SAN FRANCISCO PLANNING DEPARTMENT

Addendum to Environmental Impact Report

Addendum Date: May 9, 2013
Case No.: 2005.0555E
Project Title: California Pacific Medical Center (CPMC) Long Range Development Plan
EIR: CPMC LRDP Final Environmental Impact Report (Final EIR)
SCH No. 2006062157, Certified April 26, 2012
Zoning: Various
Height and Bulk: Various
Block/Lot: Various
Lot Size: Various
Project Sponsor: California Pacific Medical Center
Lead Agency: San Francisco Planning Department
Staff Contact: Devyani Jain – (415) 575-9051
Devyani.Jain@sfgov.org

Figure 1-40: East and West Elevation Comparison of Revised Project to Previous Project

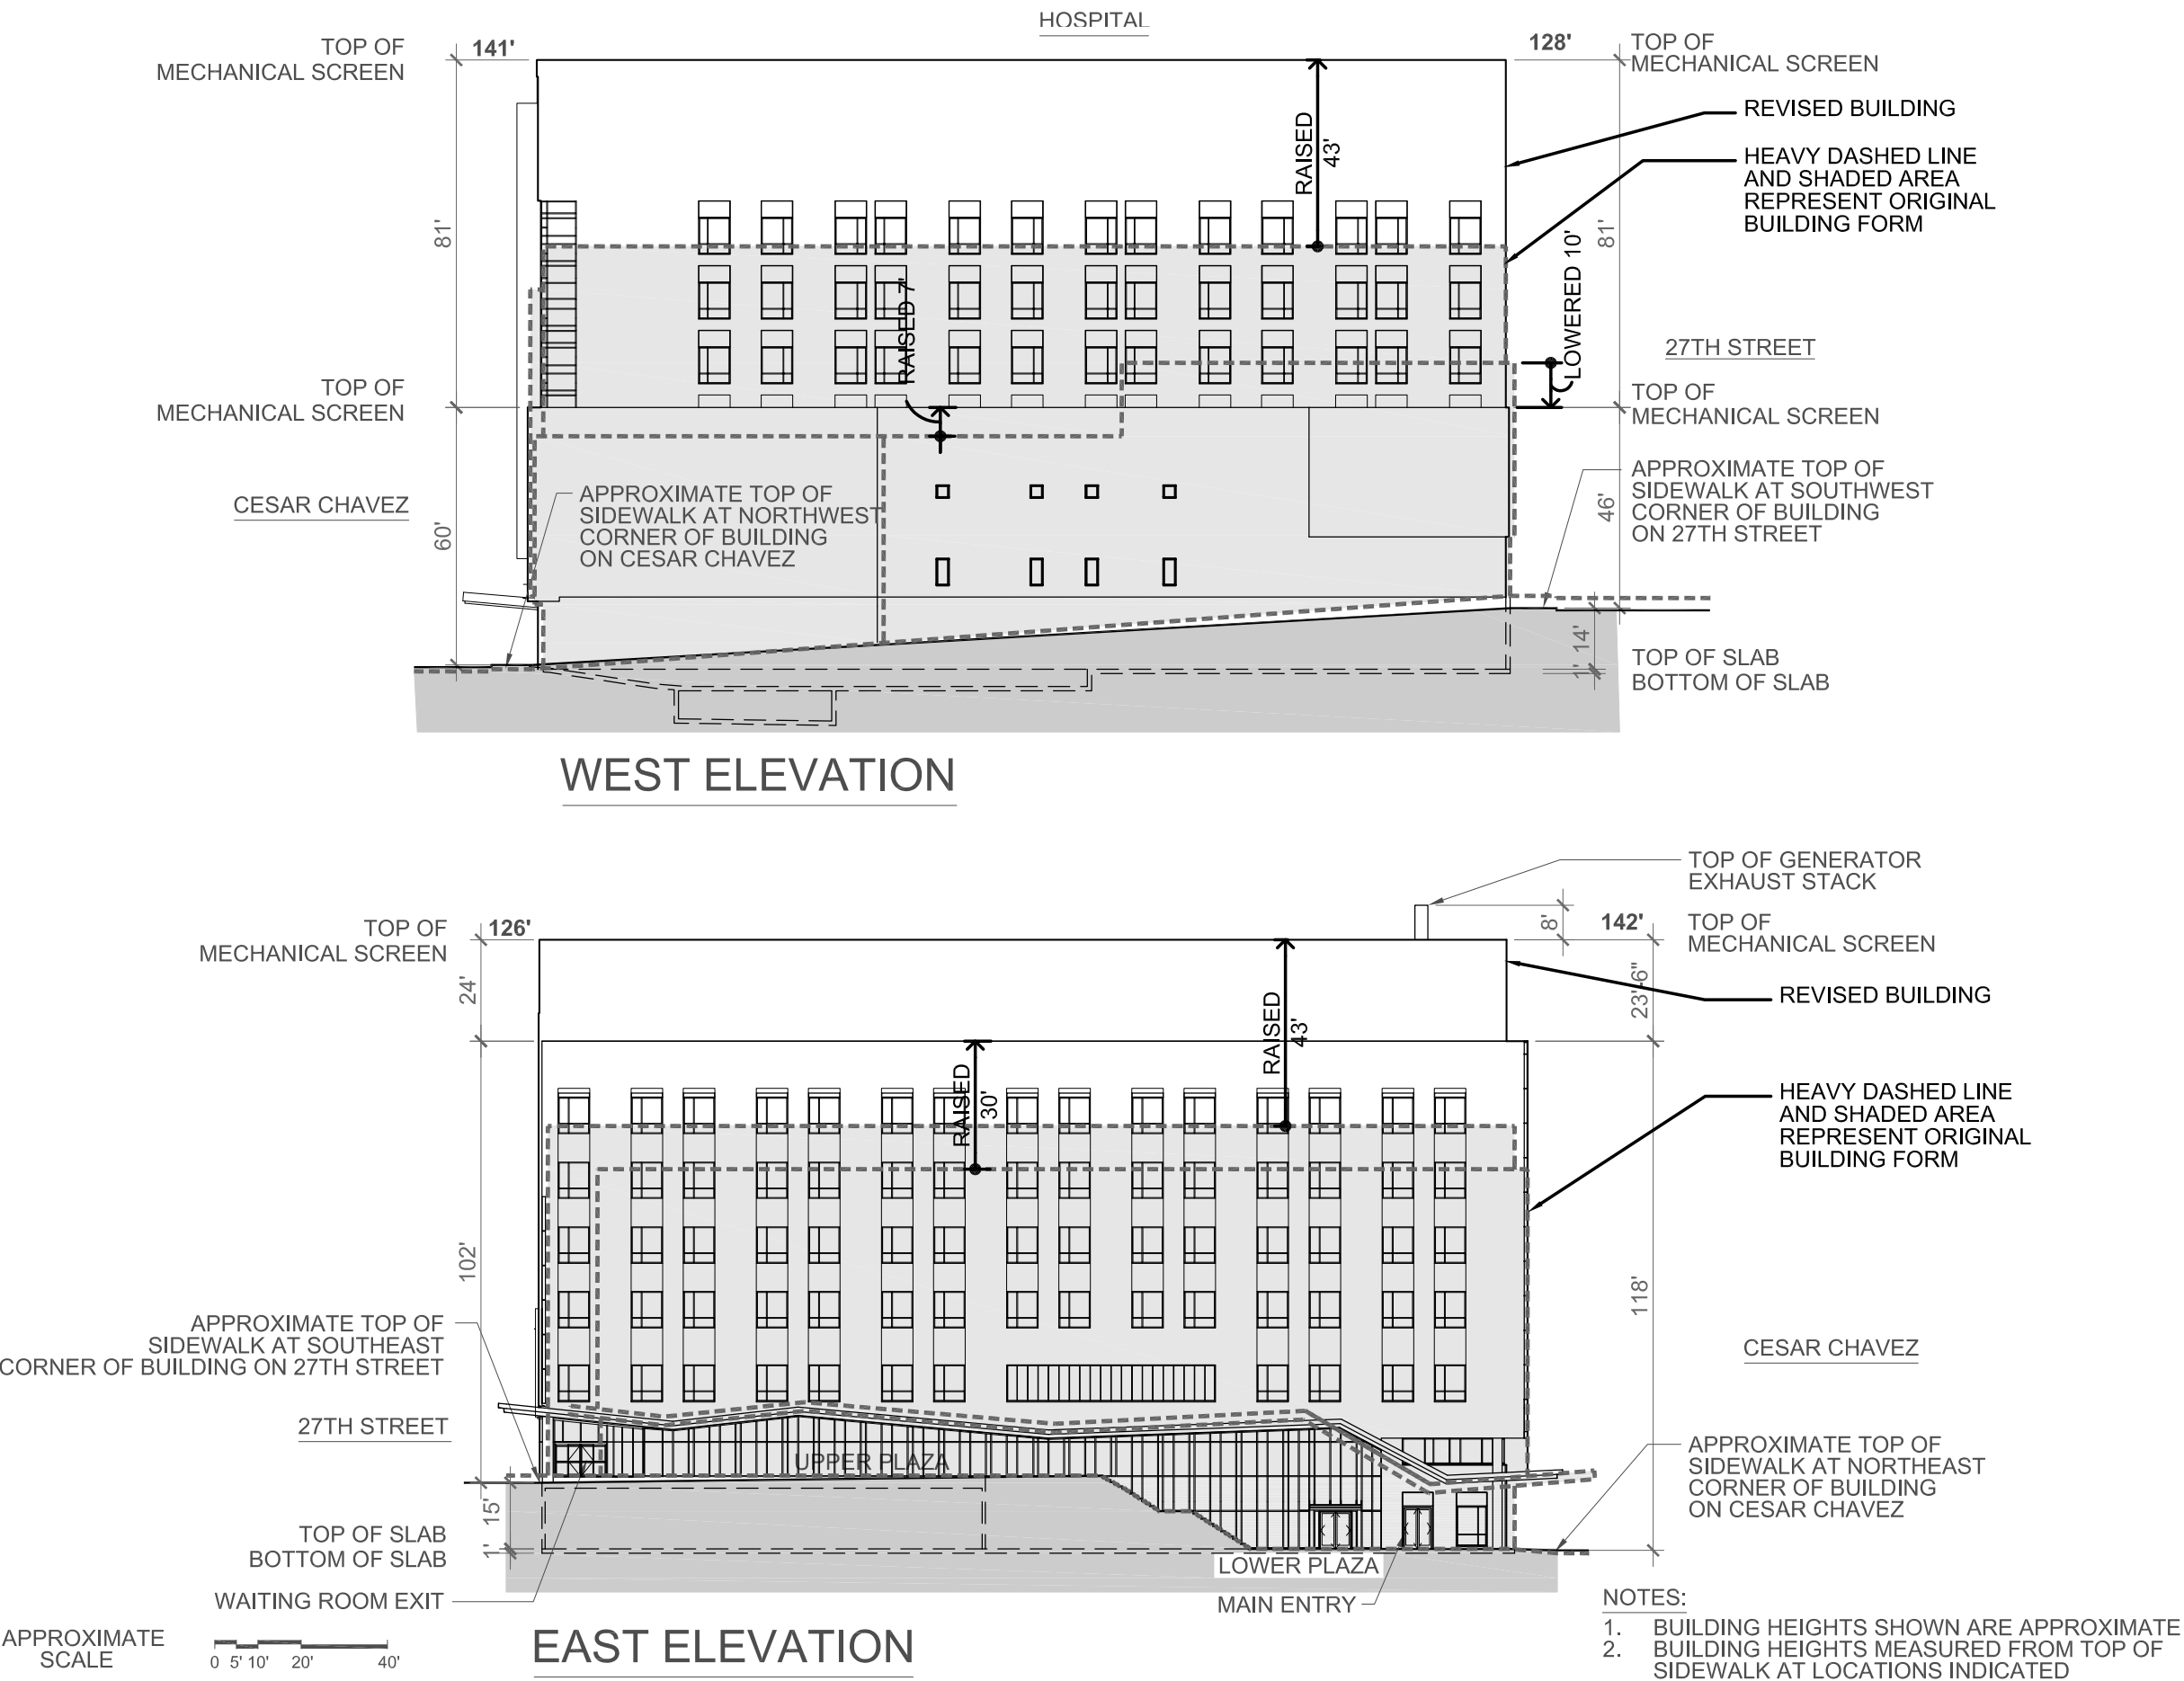
The principal changes at the St. Luke's Campus are shown in Table 2-2 and include the following: an addition of two floors (increasing the total from five to seven floors) and 43 feet (increasing the total height from 99 to 142 feet); 80,890 gsf of hospital space (increasing the total hospital floor area from the previously planned 154,800 to 235,690 gsf); and 40 additional licensed acute care beds (increasing the total from 80 to 120 beds) at the proposed St. Luke's Campus Hospital. The 80,890 gsf of additional hospital space includes an approximately 5,049-gsf building connector between the St. Luke's Campus Hospital and St. Luke's Campus MOB, which was attributed to the St. Luke's Campus MOB under the Previous Project. However, the building connector would be attributed to the St. Luke's Campus Hospital building under the Revised Project. This is because under the Revised Project, the building connector would be constructed concurrently with the hospital rather than with the St. Luke's Campus MOB, resulting in a net addition of 75,841 gsf at the St. Luke's Campus under the Revised Project as compared to the Previous Project. There would be no change to the parking spaces and building footprints at the St. Luke's Campus as compared to the Previous Project. However, there would be an incremental increase in the number of vehicular trips due to the additional 75,841 gsf (and 40 more beds) of hospital development associated with the Revised Project. Although the footprint of the St. Luke's Campus Hospital would not change, there would be approximately 9,000 additional cubic yards of excavation below grade (increasing the total excavation at the St. Luke's Campus from 61,400 under the Previous Project to 70,400 cubic yards under the Revised Project). There would be no change in the number of basement levels.

The two additional new hospital floors under the Revised Project would visually resemble the lower floors of the hospital under the Previous Project. The exterior design and architectural treatment of the two new floors would be similar to the design of the floors below and the same building façade materials would be used. Under the Revised Project, the St. Luke's Campus Hospital's exterior design would consist primarily of concrete, metal and glass, similar to the St. Luke's Campus Hospital design analyzed in the Final EIR for the Previous Project. Figures 1-30 through 1-32 includes elevations from each side of the campus. Figures 1-39 through 1-41 show a comparison of the North, South, East, and West Elevations of the hospital under the Previous Project to those of the Revised Project.
